U S NAVY RESPONSE TO U S EPA REGION III ADDITIONAL COMMENTS TO DRAFT SAMPLING AND ANALYSIS PLAN SITE 7 EXPANDED REMEDIAL INVESTIGATION NWS YORKTOWN VA
6/13/2012
CH2M HILL

Subject: Response to Additional Comments received June 4, 2012 on the Draft Sampling and Analysis Plan, Site 7 Expanded Remedial Investigation, NWS Yorktown, Yorktown, Virginia

Figure 1
Site 7 Proposed Soil Sample Locations
Naval Weapons Station Yorktown
Yorktown, Virginia

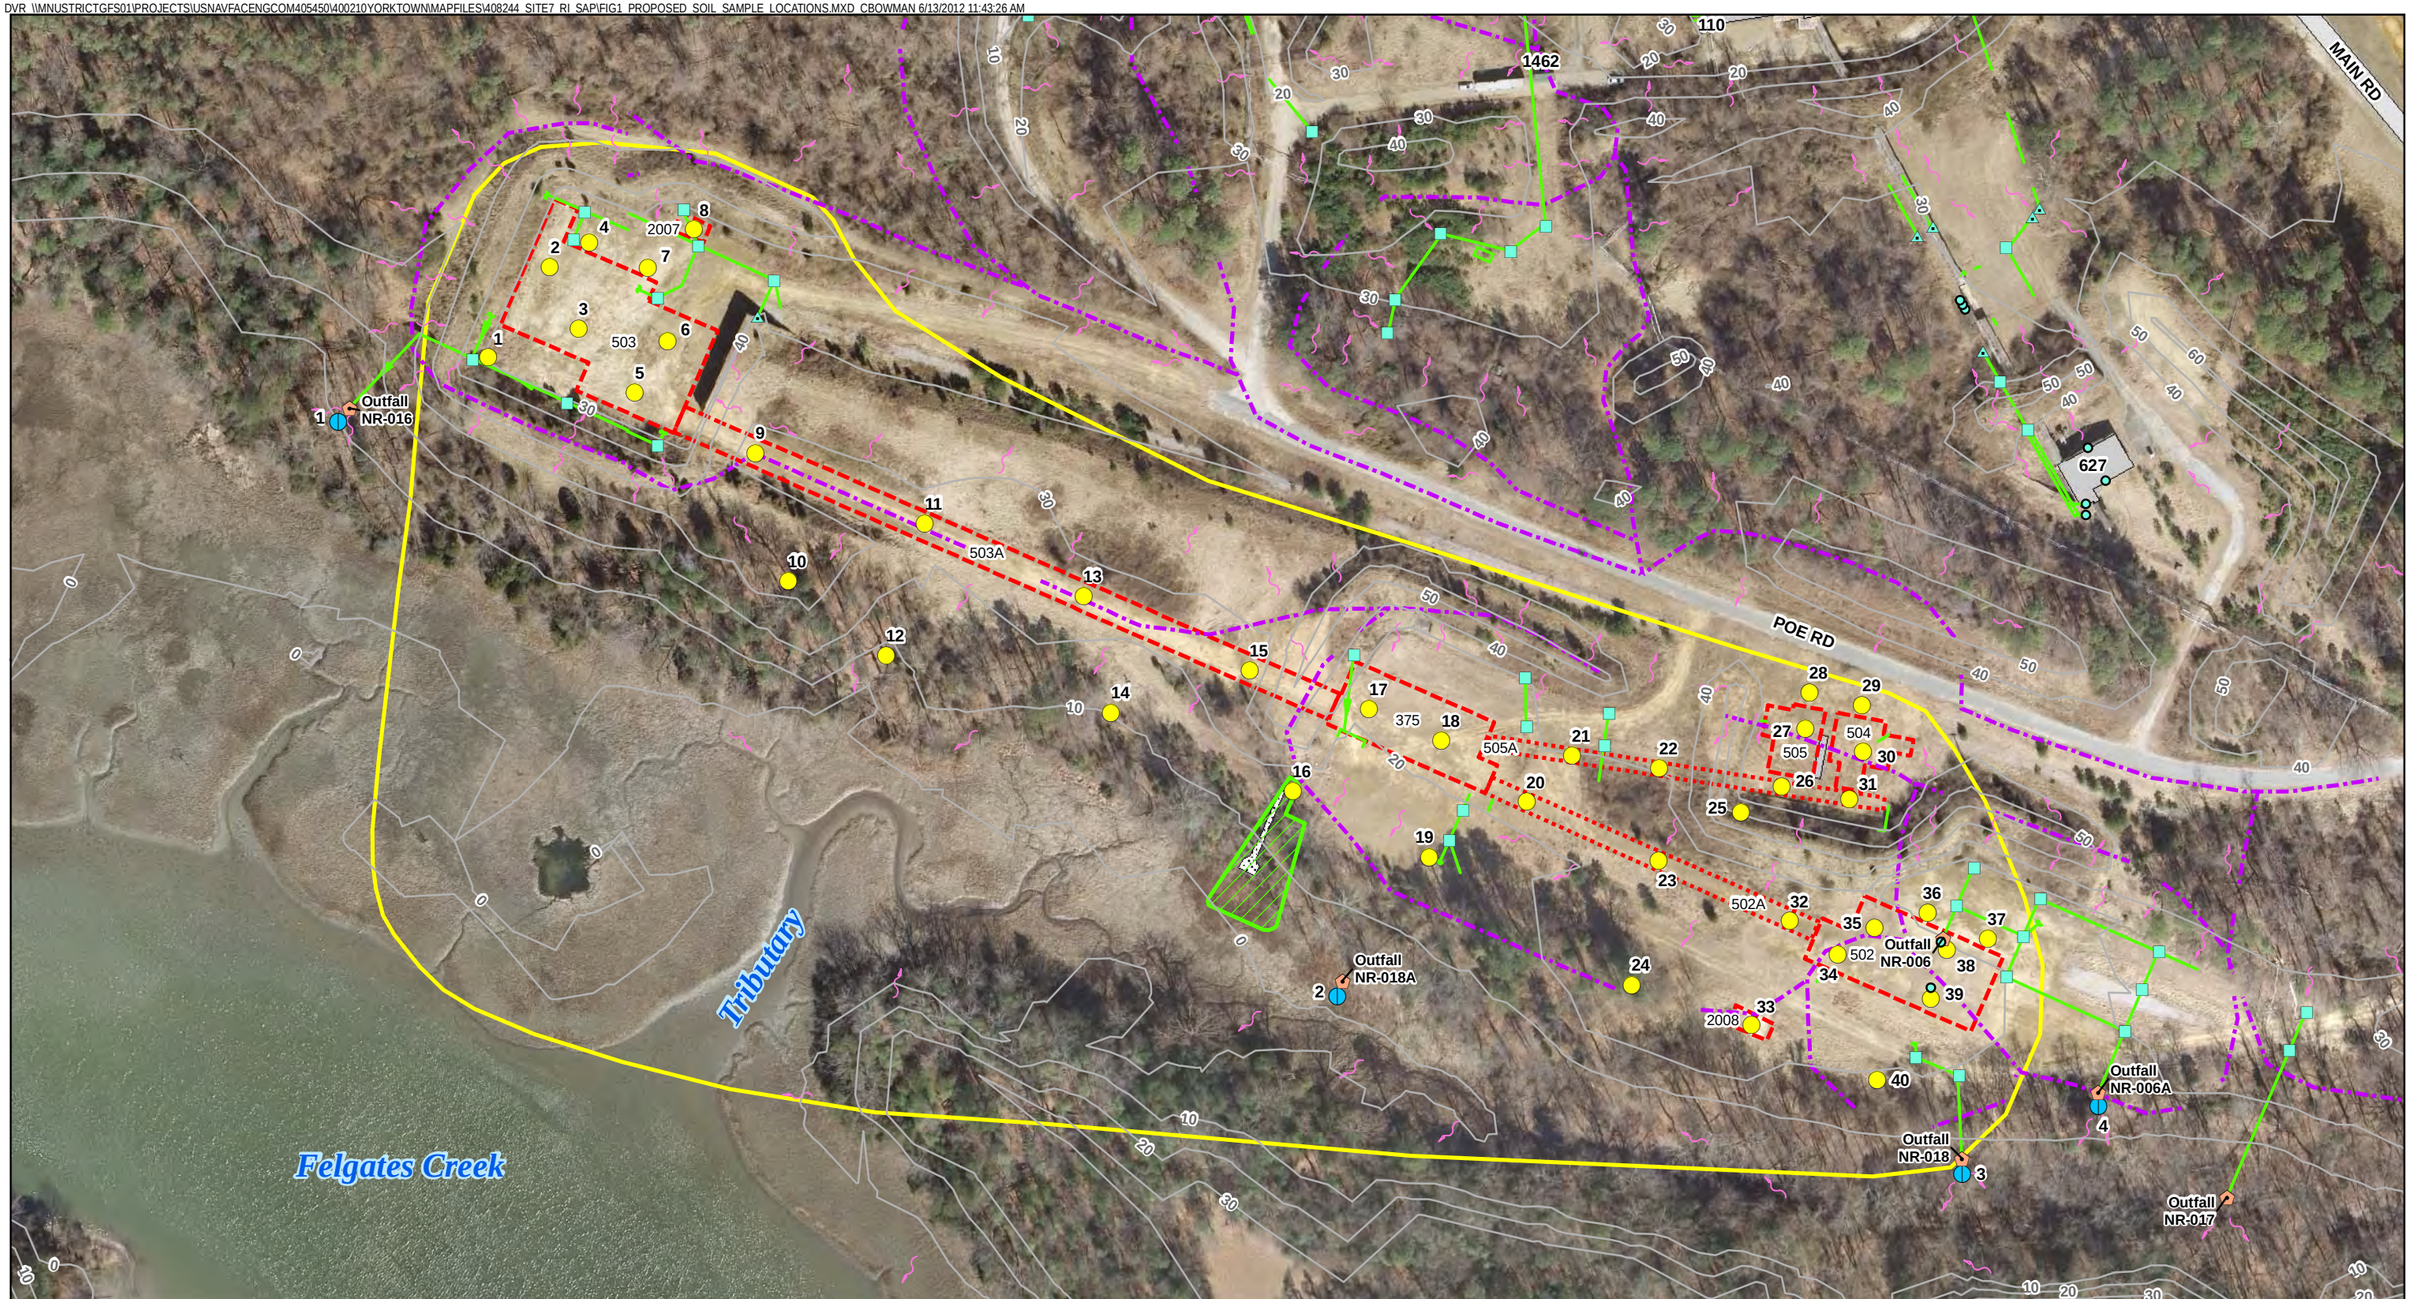
Comment 1: After reviewing Response 1, it has been concluded that additional samples need to be located where contaminants / chemicals potentially entered or left buildings 375, 502, 503, 504, 505, 2007, 2008, 503A, 502A, and 505A. Also, for conveyor belt building 505A, there needs to be three samples placed similarly to those in building 502A.

Comment 2: According to Figure 1, sample location 24 is not under either Building 504 or 505, but between them and the description provided in the table is not adequate. A minimum of two additional samples in each of these former buildings need to be added.

Comment 4: Bullet 6 of Comment 2 recommended that areas downgradient of all outfall structures needed to be sampled. The RTC (bullet 6) stated that the Navy agrees to collect a sediment sample from each downgradient outfall location as shown in Figure 1. Figure 1 shows all four outfall samples are right at the pipe. Many of these outfall pipes had scour holes immediately below the pipe because of the drop in elevation between the pipe and creek. These scour holes are not depositional and it would not be appropriate to sample in these areas. The sample should instead be collected at the first depositional area downgradient from the pipe. In most cases, this would be in the floodplain of the tributary of Felgates Creek and may be ten or more feet from the actual pipe.

> *Response: Please refer to the attached proposed sampling figure and table, which outlines the addition of 9 more soil sample locations (for a total of 40 locations) agreed to during the May 30th and 31st WPNSTA Yorktown partnering meeting. Samples have been added at potential loading/unloading points, along conveyor belt 505A, and with increased frequency within the former building footprints.*

> *Response: Please see response to Comment #1. Additional sample locations have been added in and around these two buildings.*

Response: Outfall sediment sample locations will be field determined and will be located at the first depositional area downgradient of each outfall. A note has been added to the attached figure and table and this approach will be outlined in the SAP.
